MONROE COUNTY, NEW YORK

ADDENDUM NO. 2

**MONROE COMMUNITY COLLEGE
2011 WINDOW REPLACEMENT AND CONCRETE/BRICK REPAIR
DECEMBER 2010
Bids Due: January 6, 2010 at 2:00 PM,**

Prepared by:
DeWolff Partnership Architects LLP
151 St. Paul Street
Rochester, New York 14604

1-92 REV 2-14

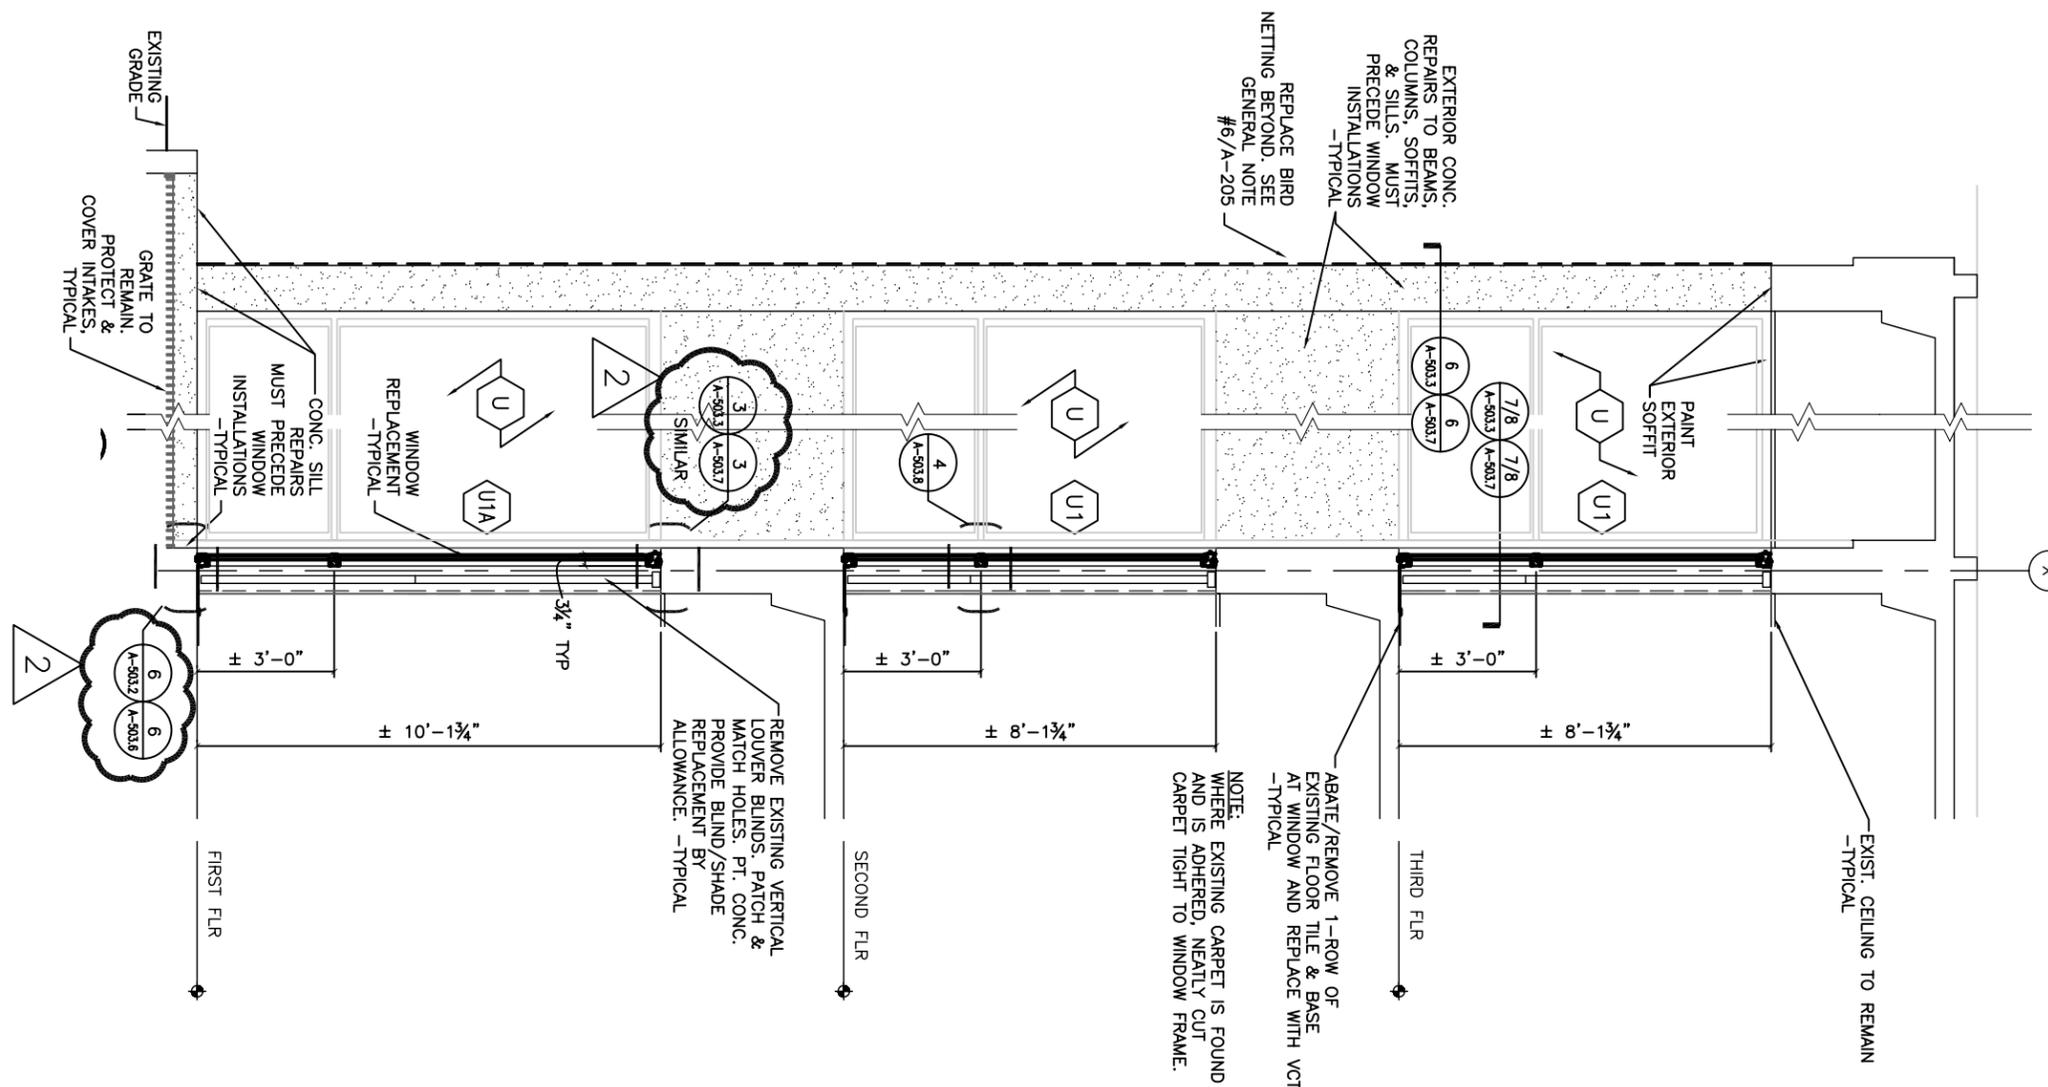
2-14 Partial Wall Section 1/A-403.2:
ADD: REPLACE PARTIAL WALL SECTIONS 1/A-403.2 WITH ATTACHED PARTIAL WALL SECTIONS 1 AS FOUND ON ADDENDUM 2 DRAWING 1-92, REVISION 2-14.

1-96 REV 2-15

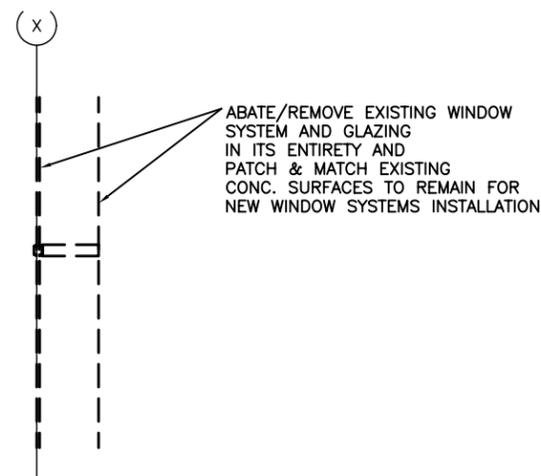
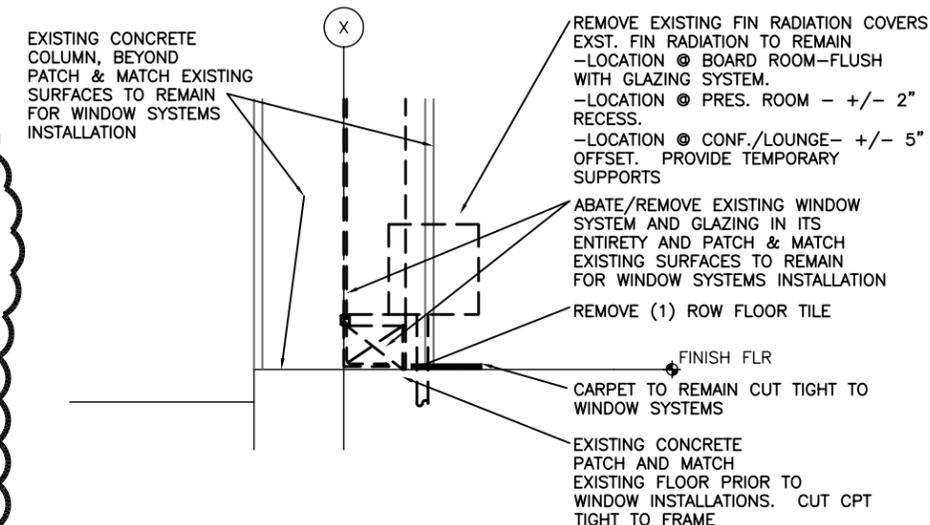
2-15 Details 7, 8 & 9 /A-503:
ADD: REPLACE DETAILS 7, 8 & 9/A-503 WITH ATTACHED DETAILS 7 & 9, AS FOUND ON ADDENDUM 2 DRAWING 1-96, REVISION 2-15.
DELETE: DETAIL 8/A-503.

1-100 REV 2-18

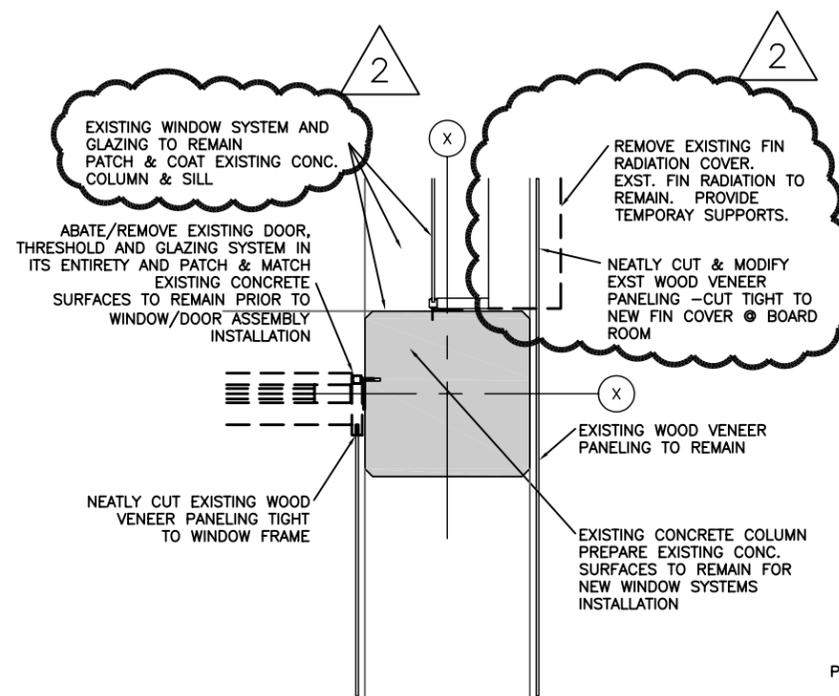
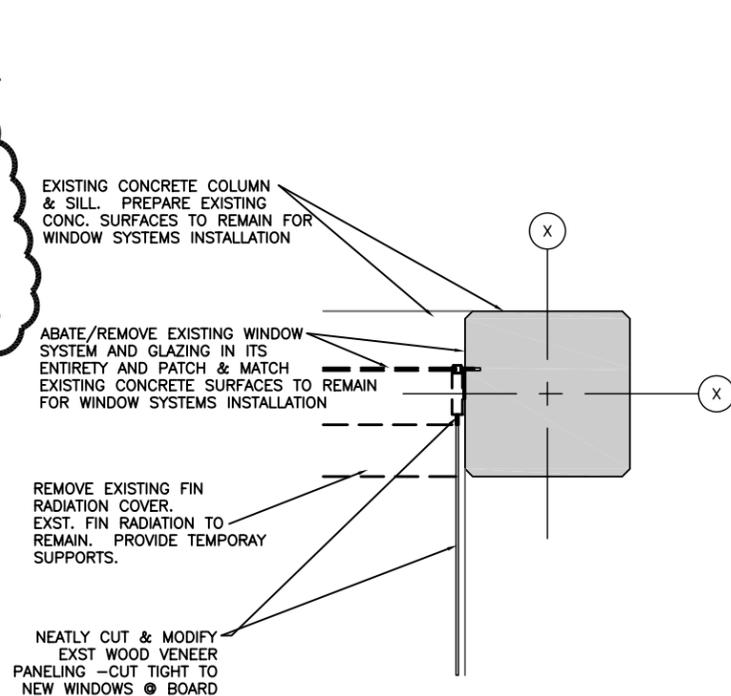
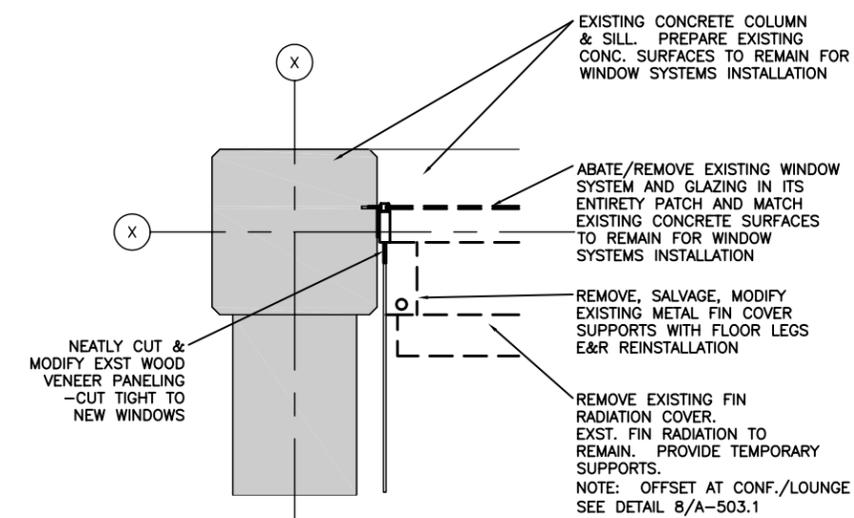
2-18 Details 3, 4 & 5 /A-503.1:
ADD: REPLACE DETAILS 3, 4 & 5/A-503.1 WITH ATTACHED DETAILS 3, 4 & 5, AS FOUND
ON ADDENDUM 2 DRAWING 1-100, REVISION 2-18.

1-102 REV 2-19

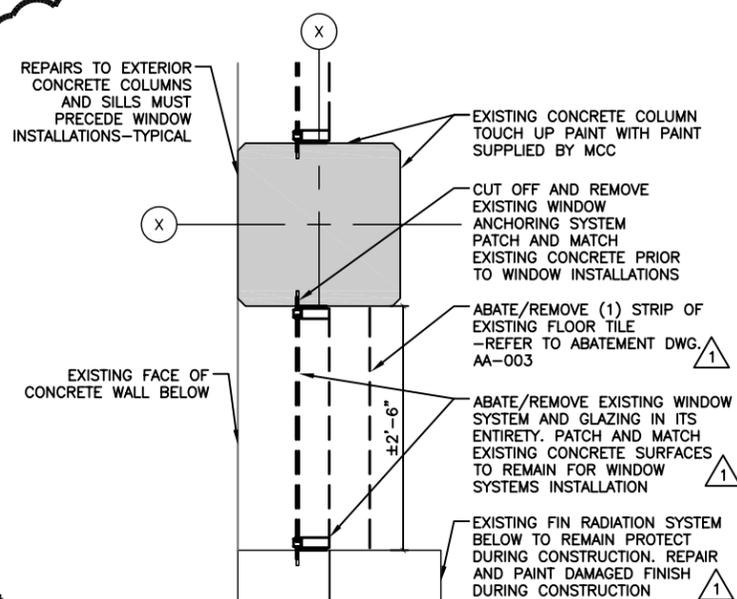
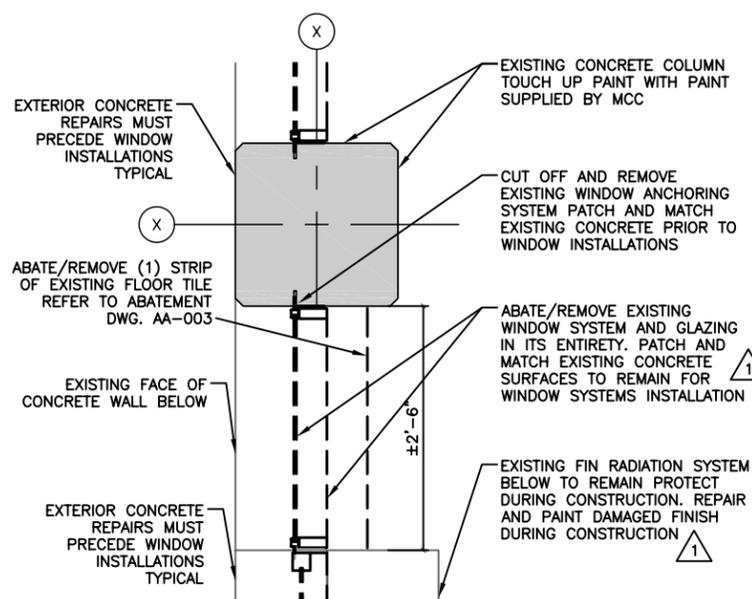
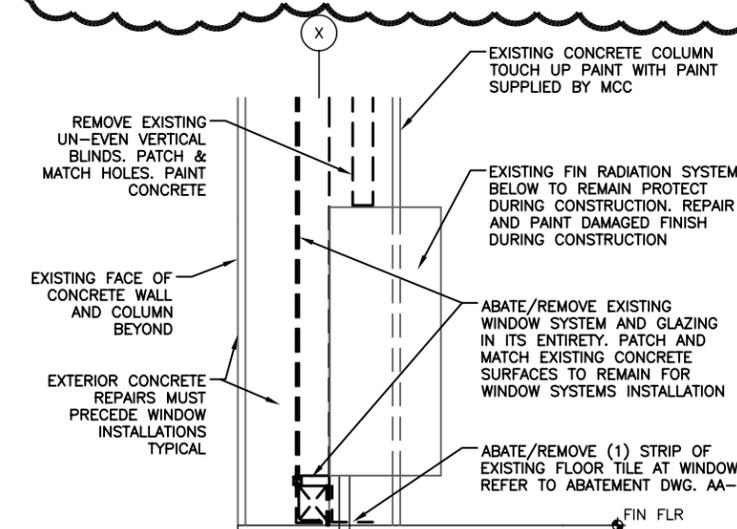
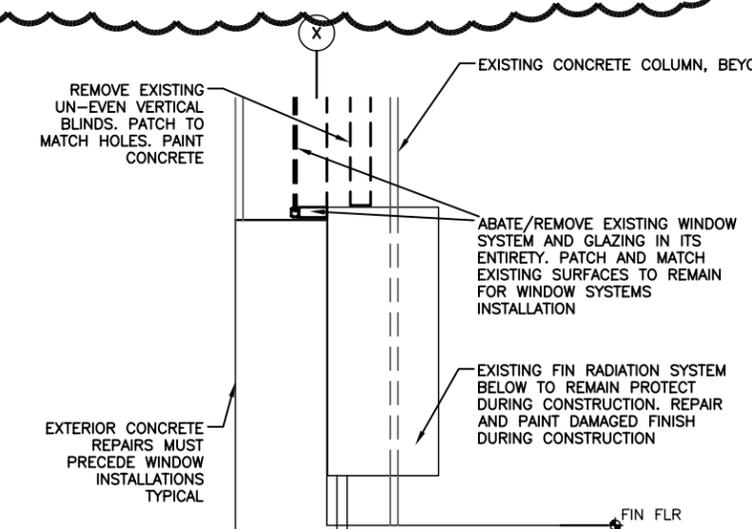
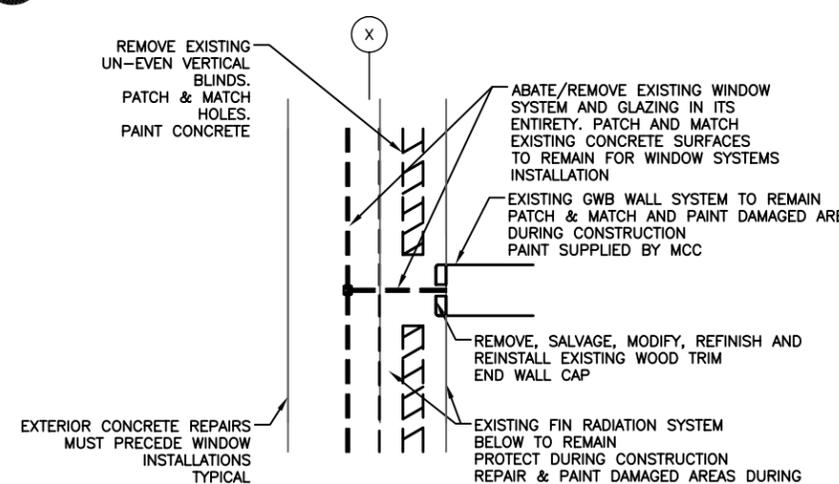
2-19 Details 2, 3, 4, 5 & 6 /A-503.2:
ADD: REPLACE DETAILS 2, 3, 4, 5 & 6 /A-503.2 WITH ATTACHED DETAILS 2, 3, 4, 5 & 6, AS
FOUND ON ADDENDUM 2 DRAWING 1-102, REVISION 2-19.

1-106 REV 2-20

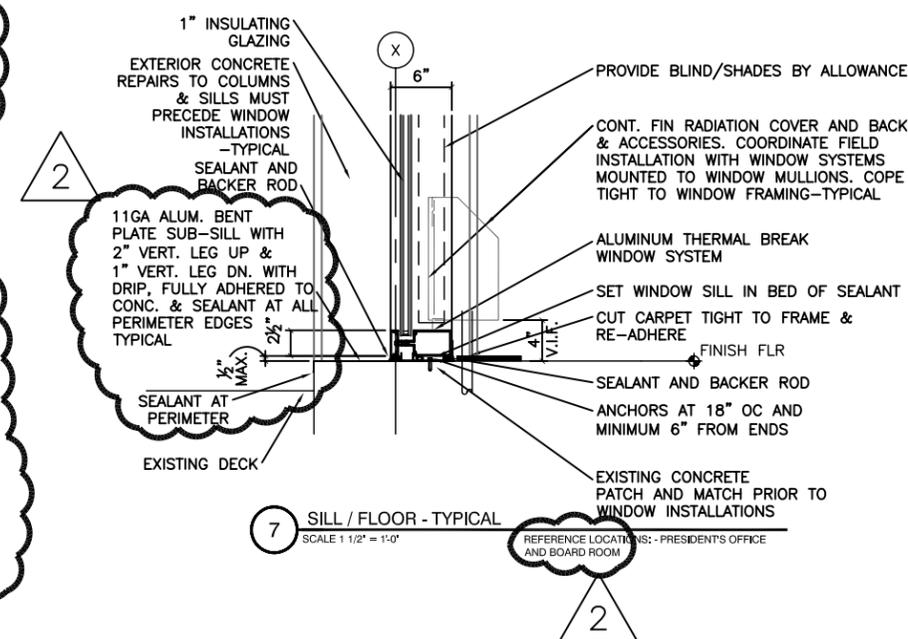
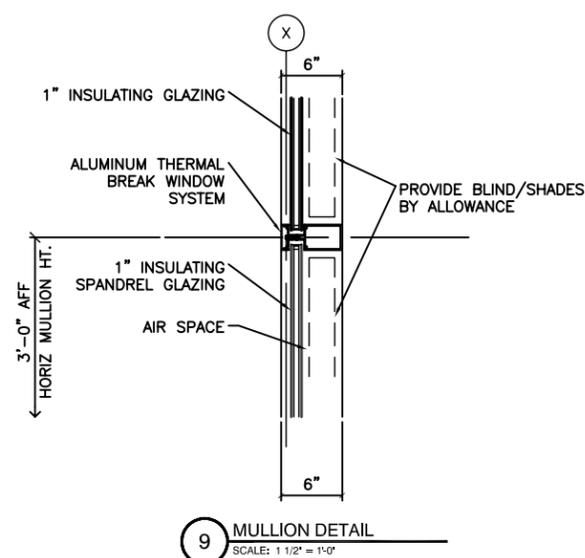
2-20 Details 7, 8 & 9 /A-503.4:
ADD: REPLACE DETAILS 7, 8 & 9 /A-503.4 WITH ATTACHED DETAILS 7, 8 & 9, AS FOUND
ON ADDENDUM 2 DRAWING 1-106, REVISION 2-20.
DELETE: DETAIL 8/A-503.4.
